Re: 710 Taylor Project

Board of Zoning Adjustment
 District of Columbia
 CASE NO. 21430
 EXHIBIT NO. 31A

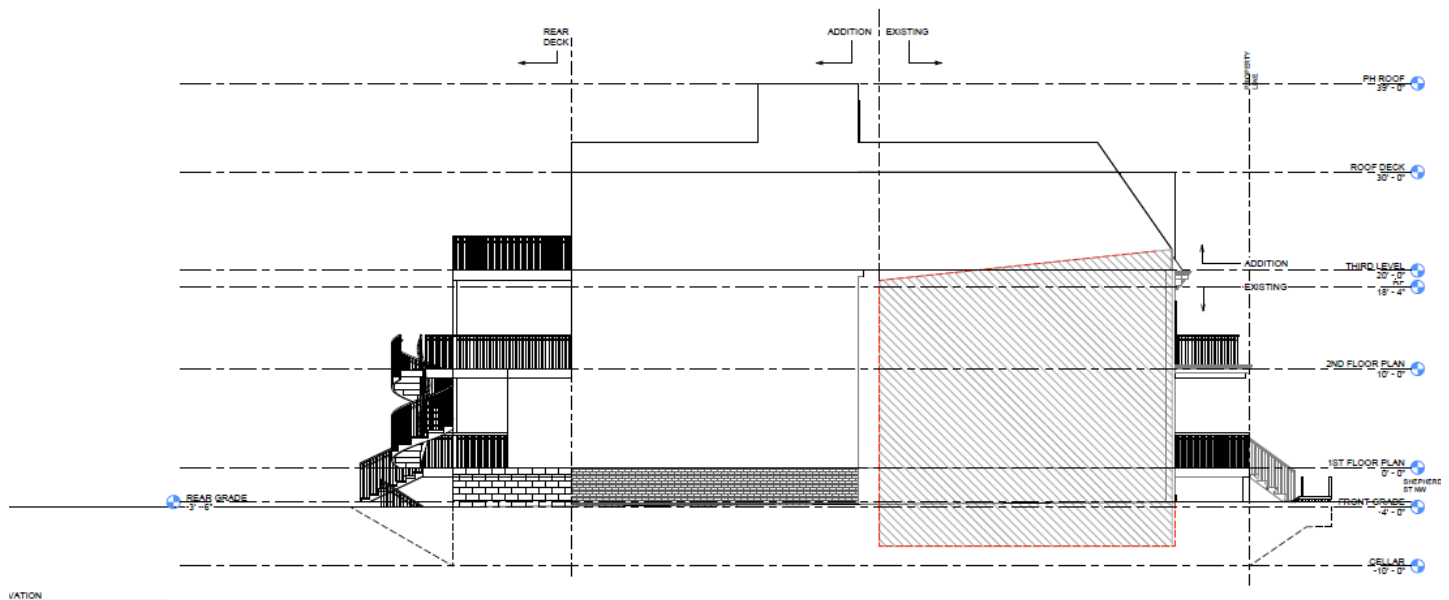
You all asked for considering opening up the solid side walls of the decks so we considered that and changed the design to reflect that. Not sure why you are saying it doesn't help with air and light but we placed railing instead of solid walls like below. It's a trade of between light&air and privacy. We typically opt in for privacy but we honored your request and replaced with railing. You can see that below. Previously attached plans should reflect the same.
